**Village of Somers
7511 12th Street
Somers, WI 53171**

**Village Work Session Meeting
Agenda
Tuesday, May 20, 2025
5:30 p.m.**

**VILLAGE OF SOMERS
VILLAGE BOARD
WORK SESSION ITEM MEMORANDUM**

TO: Village of Somers Plan Commission
FROM: Luke Godshall, Senior Land Use Planner
APPLN DATE: 03-28-25
RPT DATE: 04-28-25
MTG DATE: 05-12-25
RE: Willow Creek Rezoning & Preliminary Plat

OVERALL GRADING & EROSION CONTROL PLAN

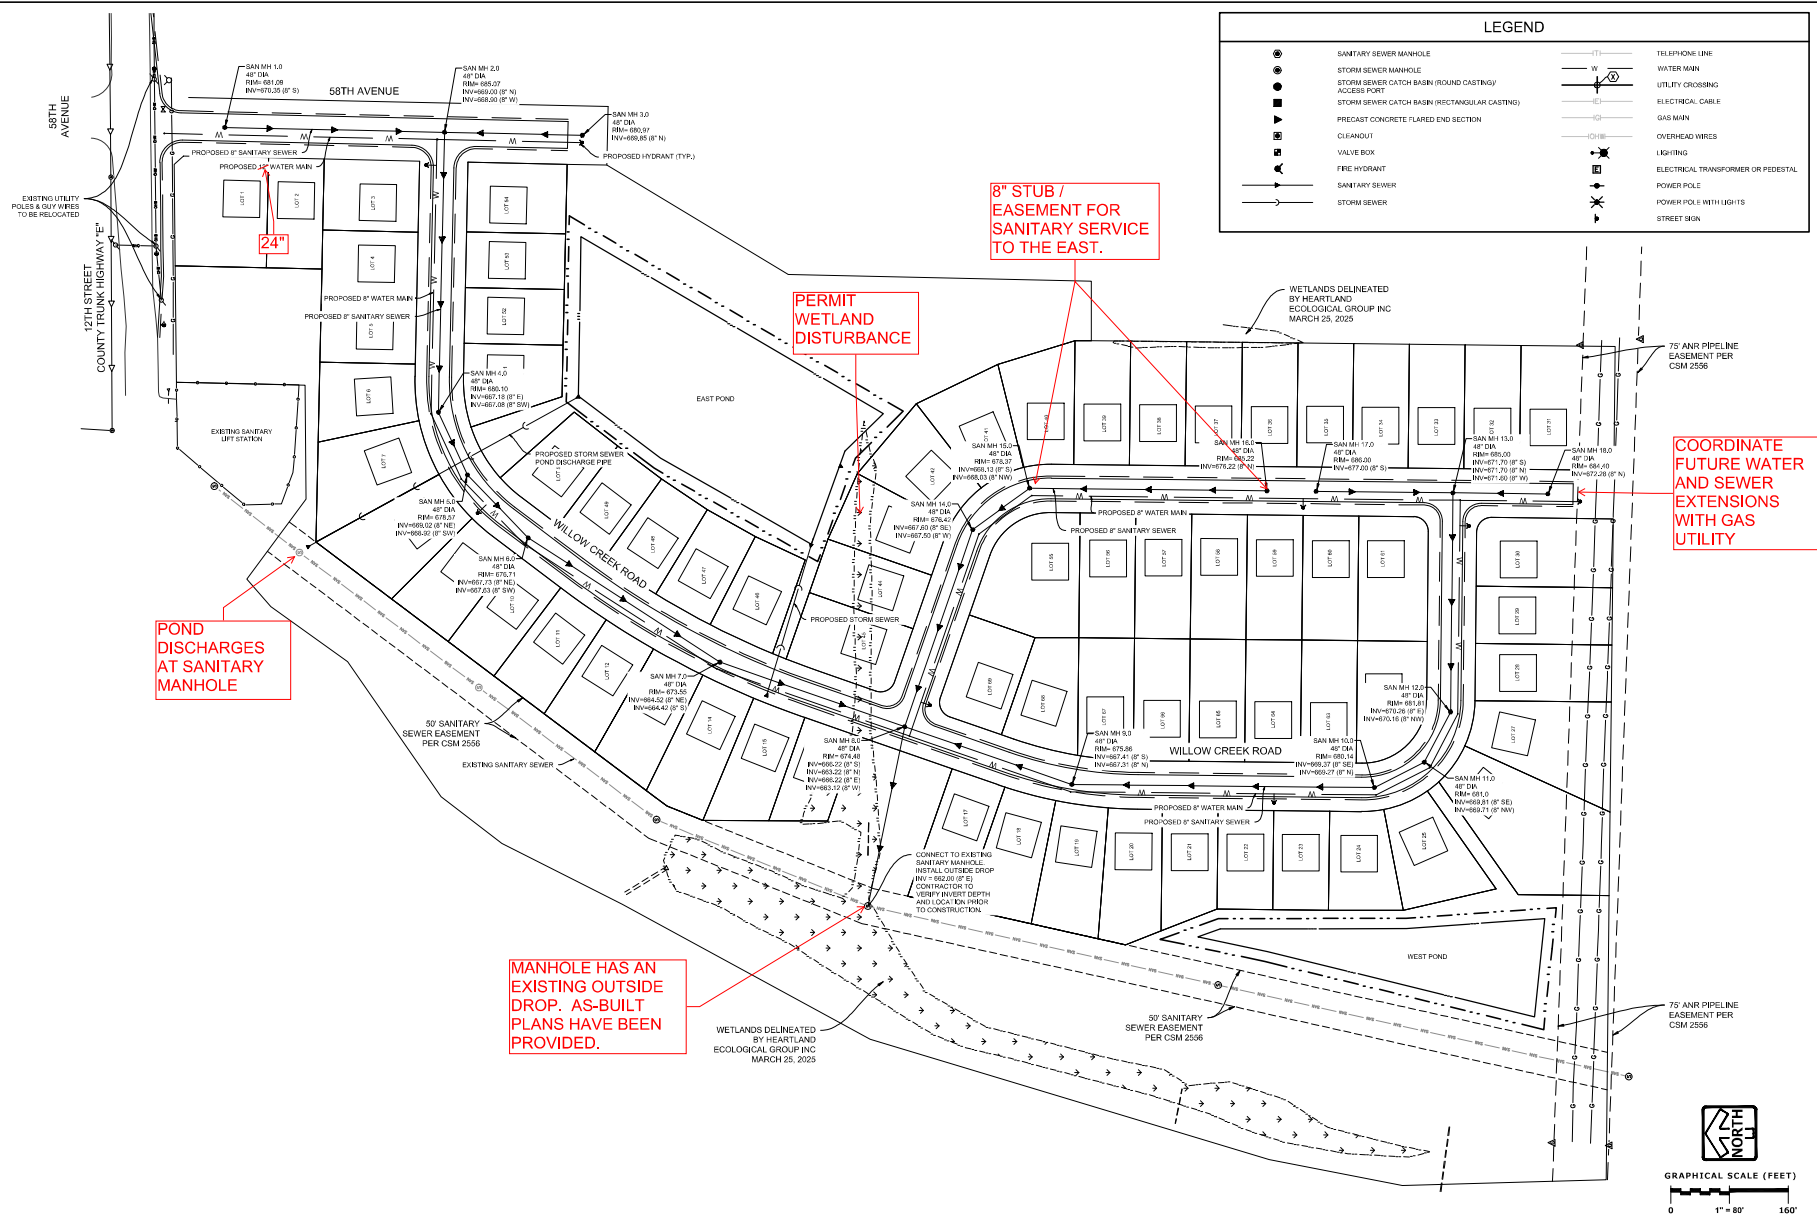
1. Sheet 3: Provide an emergency pond overland flow route.
2. Sheet 4:
 - a. Provide a 24-inch water main on the entrance road (58th Ave.).
 - b. The east pond discharge conflicts with an existing sanitary manhole.
 - c. The sanitary sewer tie-in manhole has an existing outside drop. As-builts have been provided.
 - d. Provide permit for wetland disturbance.
 - e. Provide an 8-inch sanitary sewer stub and easement to serve property to the east.
 - f. Coordinate future water main and sanitary sewer extensions to the south with the gas pipeline utility.

PRELIMINARY PLAT OF WILLOW CREEK

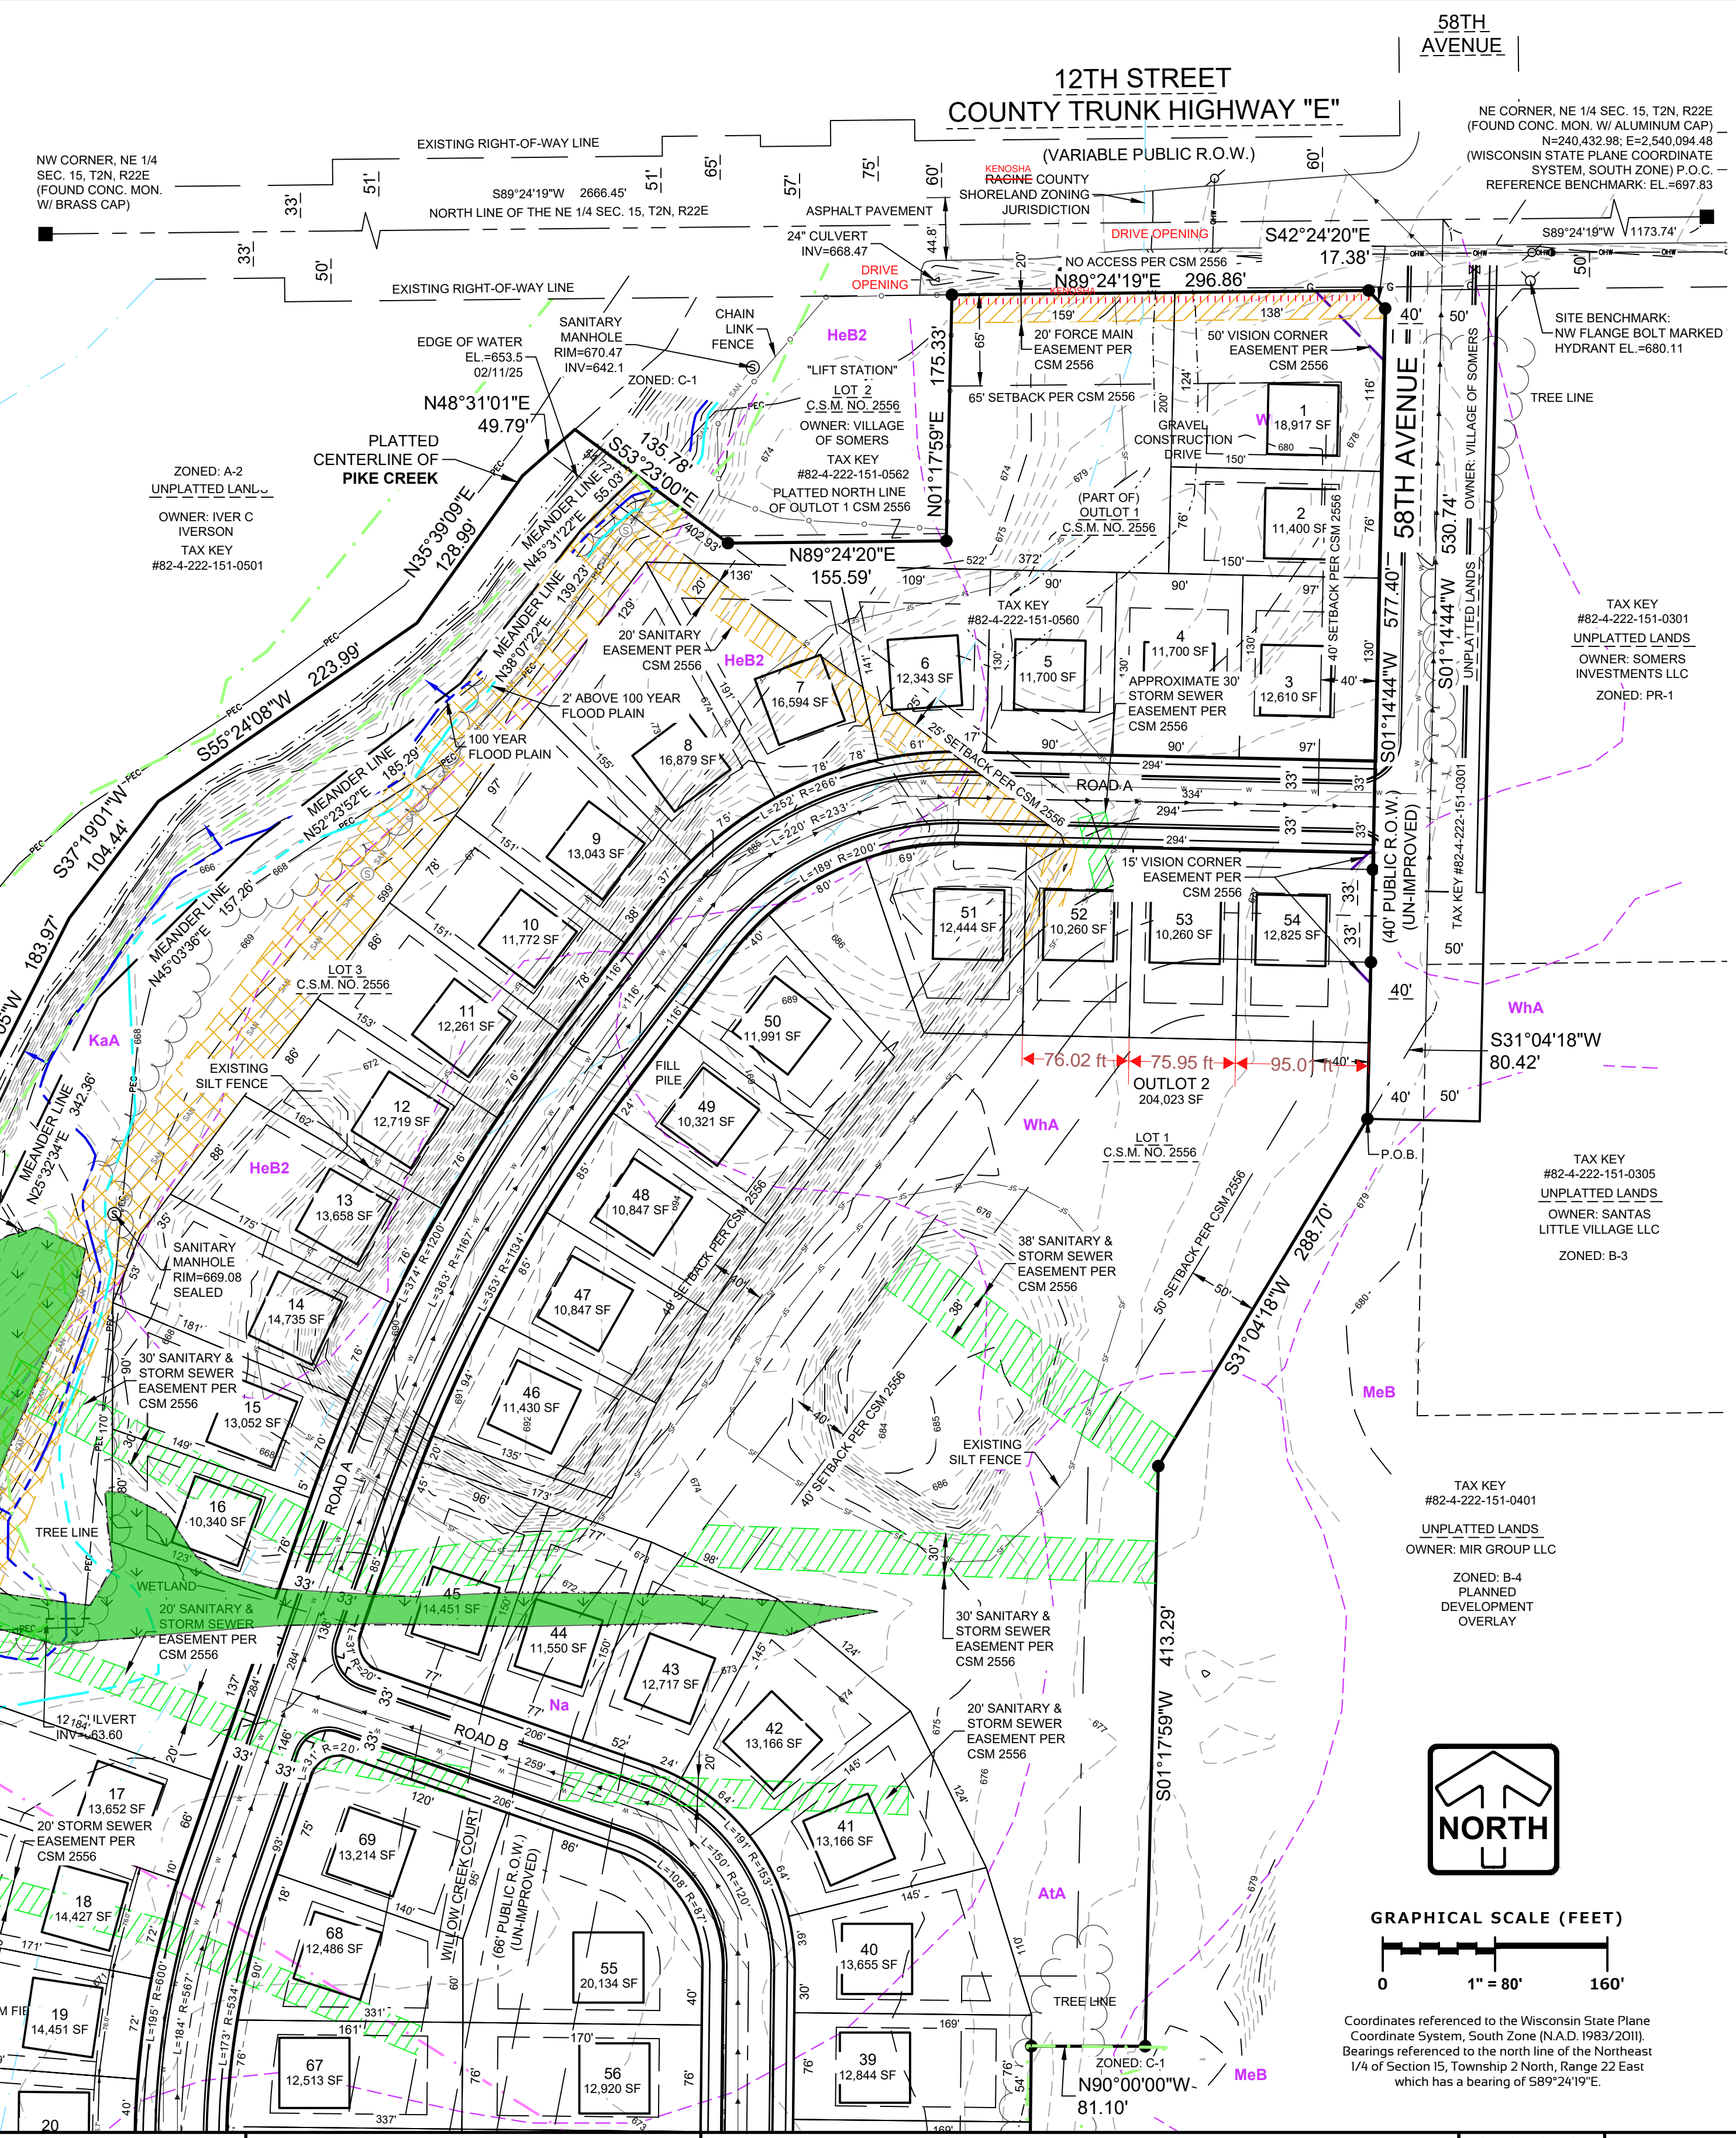
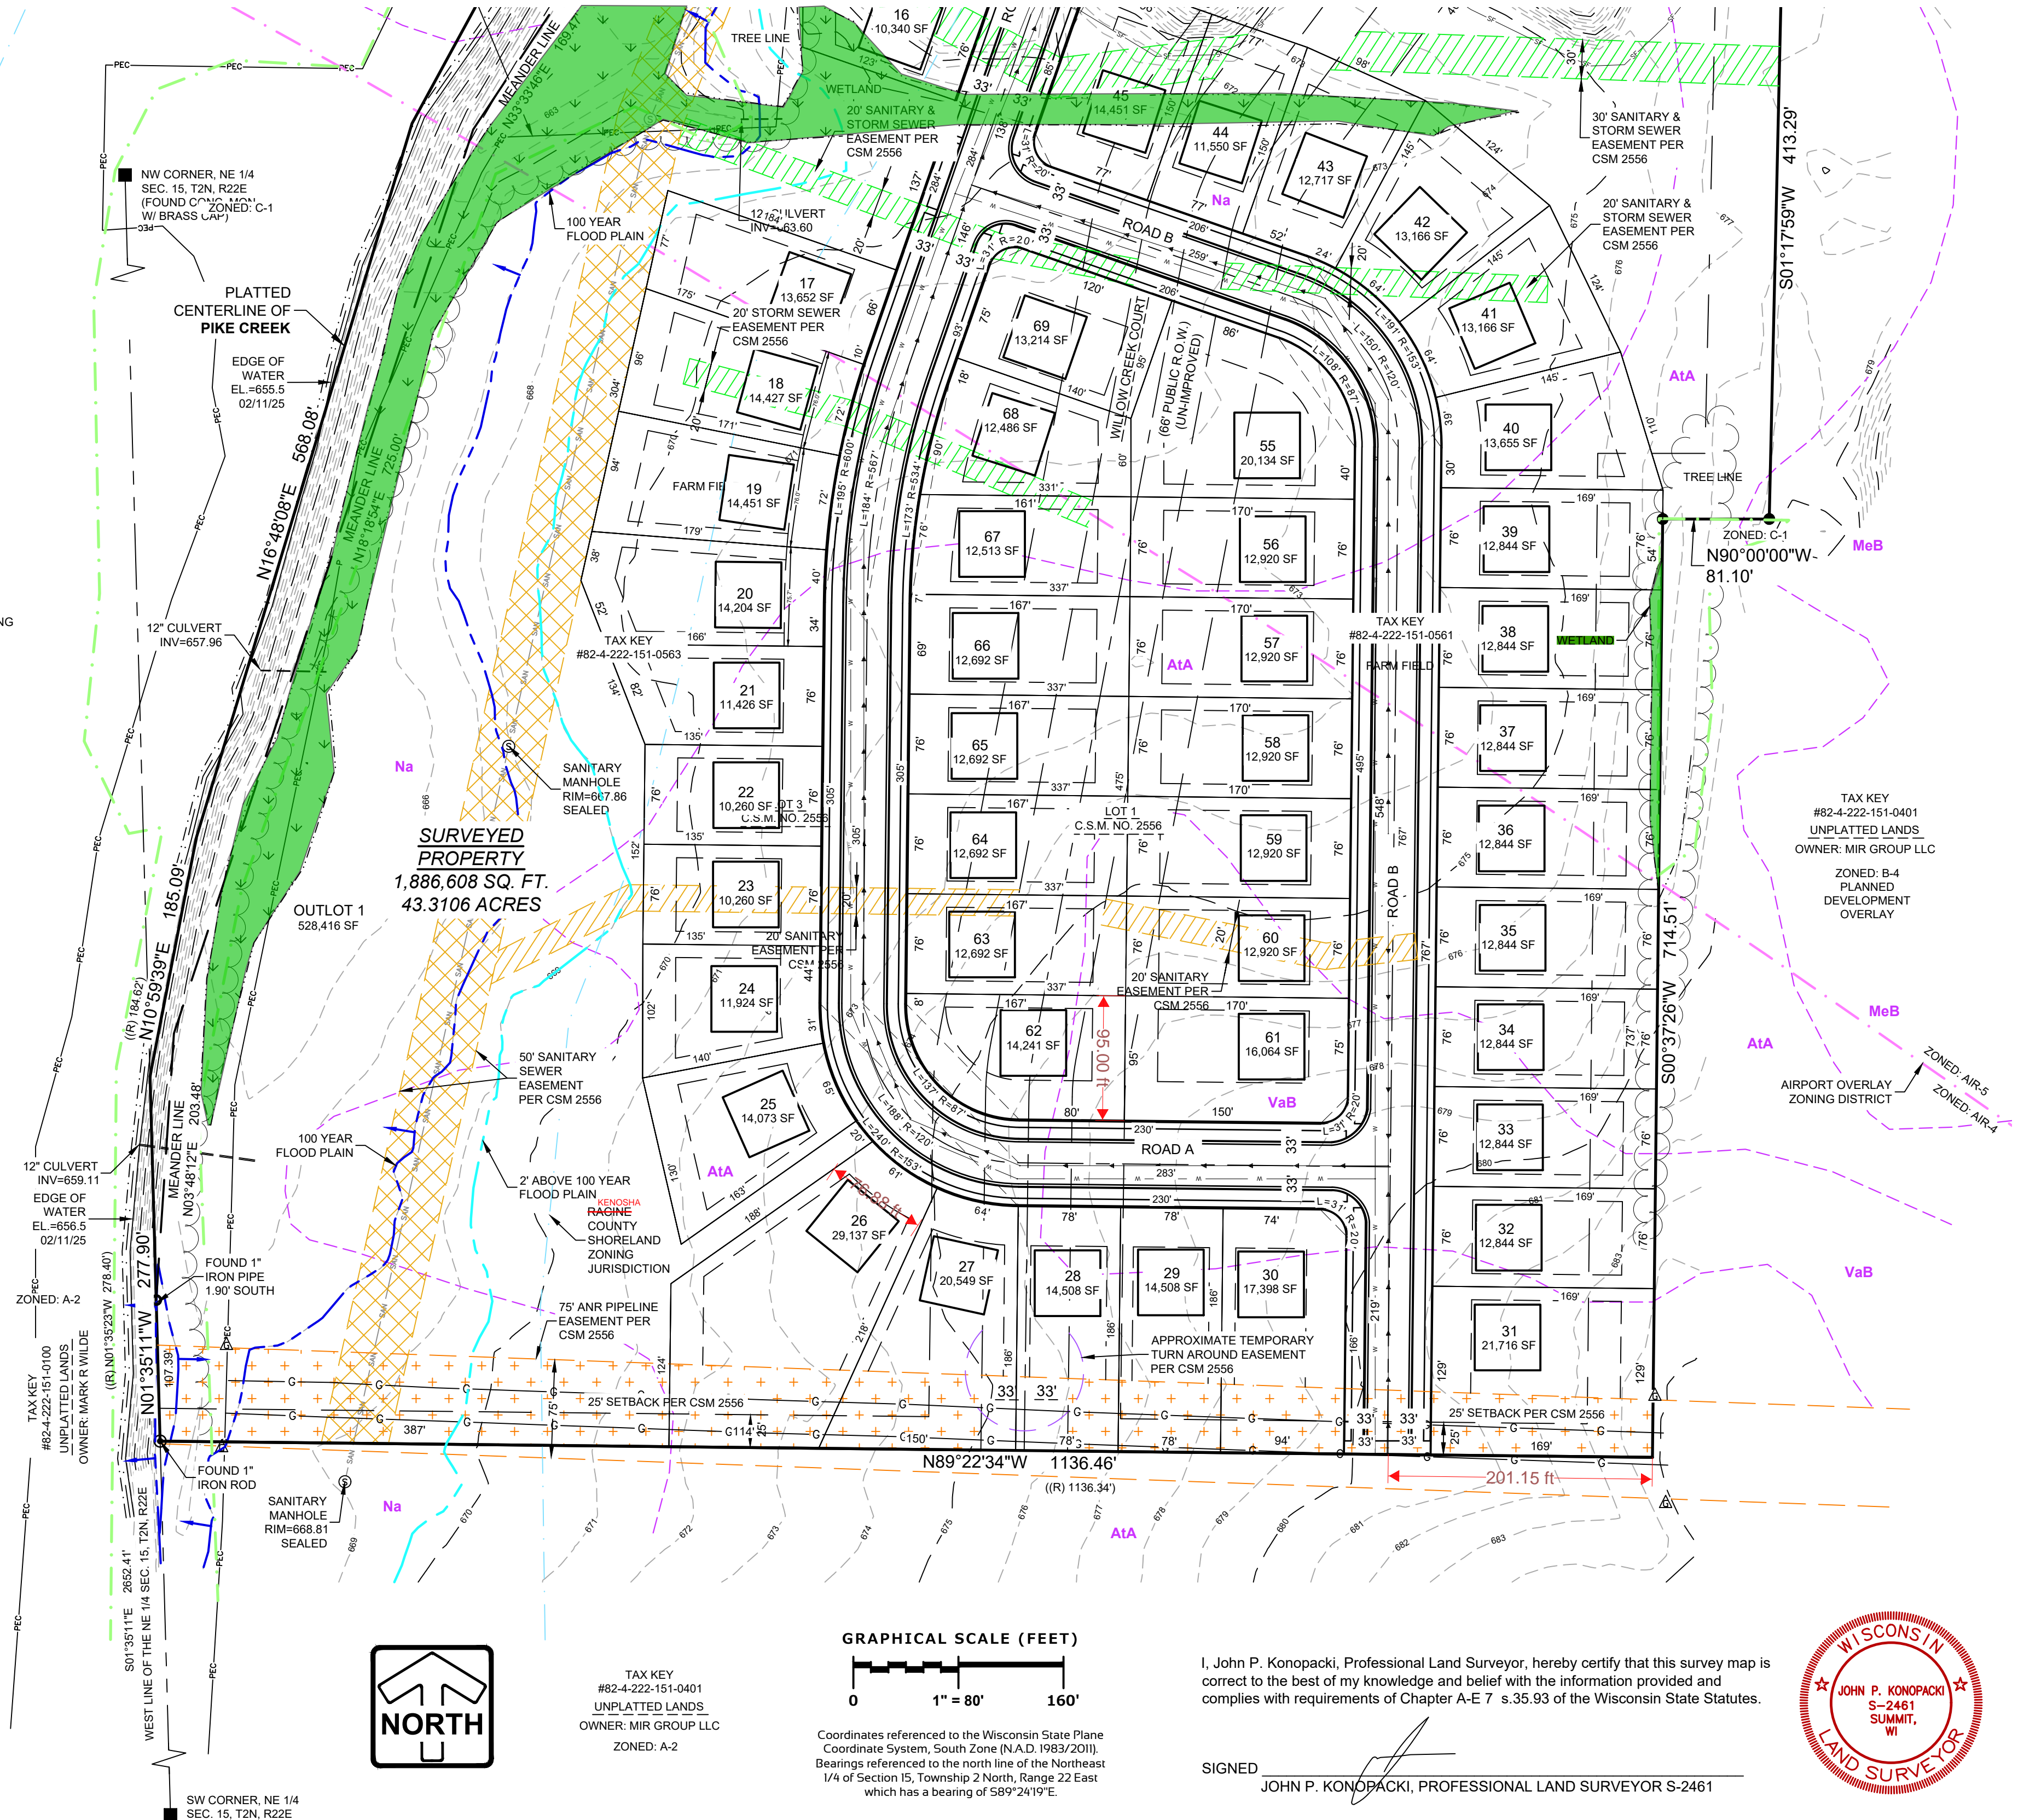
- a. Add Lot dimensions to Lots 25, 26, 27, 40, 41, 42, 43, 49, 50, 51, 52, 53, 54 to confirm conformance with R-5 zoning standards, specifically in regard to required minimum lot width of 75' (or at least 75' of width at the required building setback line if located on a cul-de-sac or curve).

- c. Add a 15'x15' vision corner easement to the southeast corner of Lot 3.
 - d. Add a 15'x15' vision corner easement to the southeast corner of Lot 54.

- e. Per Section 18.27(D)(3) of the Village ordinance, the southeast corner of Lot 3 and the northeast corner of Lot 54 shall be rounded with a minimum radius of 15 feet or of a greater radius when required by the Village Plan Commission.

- f. Per Section 18.27(C)(2) of the Village ordinance, add a temporary cul-de-sac or temporary “T” 25 feet wide extending to each adjacent right-of-way to the southern end of proposed “ROAD B”.

- g. On Sheet 2, duplicate the note from Sheet 1 indicating the adjacent unplatted tax key #82-4-222-151-0501.
 - h. On Sheets 1 and 2, add a note identifying what the green dashed & dotted line represents.

3. The following items shall be revised on the face of the preliminary plat:
 - a. In the legal descriptions on Sheets 1 and 2, revise “Town of Somers” to read “Village of Somers”.

- b. On Sheets 1 and 2, relabel “Road A” as “Willow Creek Court”, and relabel “Road B” as “61st Avenue”.
 - c. On Sheets 1 and 2, revise the Existing Zoning note to read “A-2 General Agricultural District, R-9 Multiple-Family Residential District, C-1 Lowland Resource Conservancy District, Airport Overlay Zoning Districts AIR-4 & AIR-5”.

- d. On Sheets 1 and 2, revise the Proposed Zoning note to read “R-5 Urban Single-Family Residential District & C-1 Lowland Resource Conservancy District”.

- e. On Sheets 1 and 2, revise “Proposed Zoning Requirements” to read “R-5 Urban Single-Family Residential District Requirements”.
 - f. On Sheets 1 and 2 under the Zoning Requirements section, revise “Front” to read “Street Yard” and revise “Front Street” to read “Street Yard”.

- g. On Sheets 1 and 2, revise notations of “Racine County Shoreland Zoning Jurisdiction” to read “Kenosha County Shoreland Zoning Jurisdiction”.
 - h. On Sheets 1 and 2, revise the note for the zoning of adjacent parcel 82-4-222-151-0401 to read “Zoned: B-4 Planned Business District, PUD Planned Unit Development Overlay District & A-2 General Agricultural District”.

- i. On Sheet 1, revise the note for the zoning of adjacent parcel 82-4-222-151-0501 to read “Zoned: A-2 General Agricultural District & C-1 Lowland Resource Conservancy District”.

- j. On Sheet 2, relocate the text “ZONED: C-1” so that it does not overlap the text referring to the Sec. 15 monument.
 - k. In Note 13 on Sheet 2, confirm the date of the wetland delineation by Heartland Ecological Group, Inc. (Note 13 indicates wetlands were delineated September 2024, but the submitted Site Plan from Pinnacle Engineering Group dated 3/28/25 indicates the wetlands were delineated March 25, 2025).

- l. On Sheet 2, in the third (3rd) bullet point under the WETLAND PRESERVATION AND PRIMARY ENVIRONMENTAL CORRIDOR RESTRICTION note, replace “Kenosha County” with “the Village of Somers”.

- m. On Sheet 2, revise the surveyor’s certification to include language certifying that the preliminary plat is a correct representation of all existing land divisions and features and that the plat complies with the provisions of Chapter 18, the Village of Somers Land Division and Platting Control ordinance.
